# SERVICE BULLETIN # 00054

**SUBJECT:** Validator Interface Changes from Version 1.00/2.00 to Version 5.00 and Above Control Boards

**MODELS:** Merlin 2000 with Version 5.00 and Above Control Boards

**Revision 1.00/2.00**

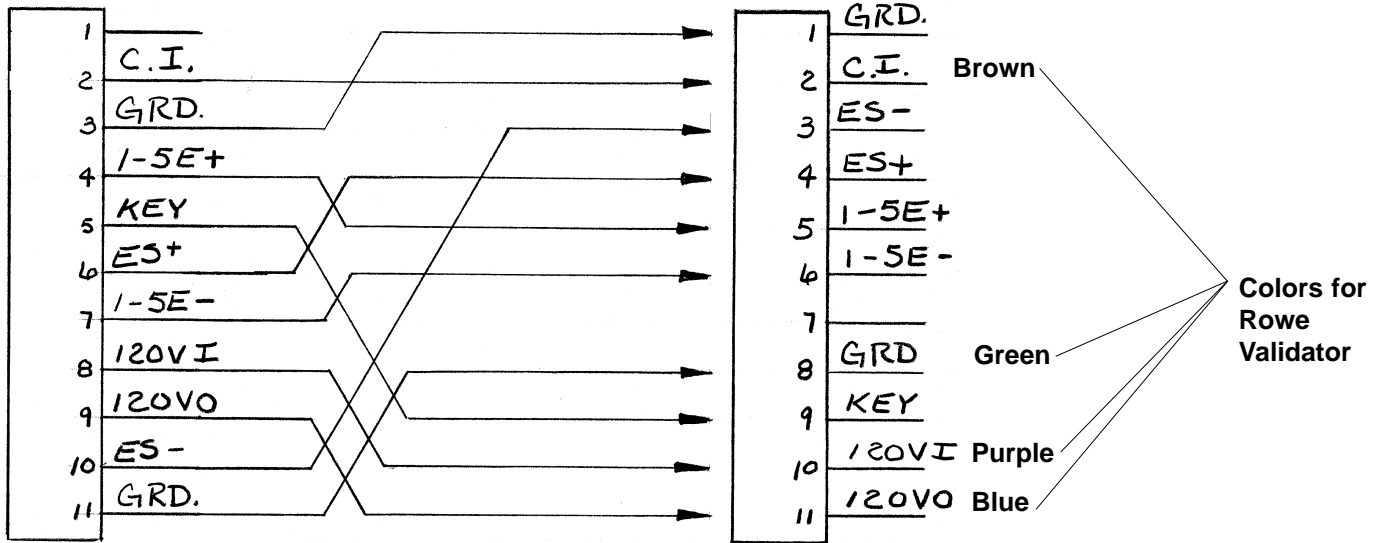
1. Validator Circuit Board Plug can be rearranged per below diagram in the absence of validator interface (842066), which can be ordered from Royal Vendors.
2. Validator Harness does not have wire numbers. The designations below are for reference only.

**Revision 5.00 and Up**
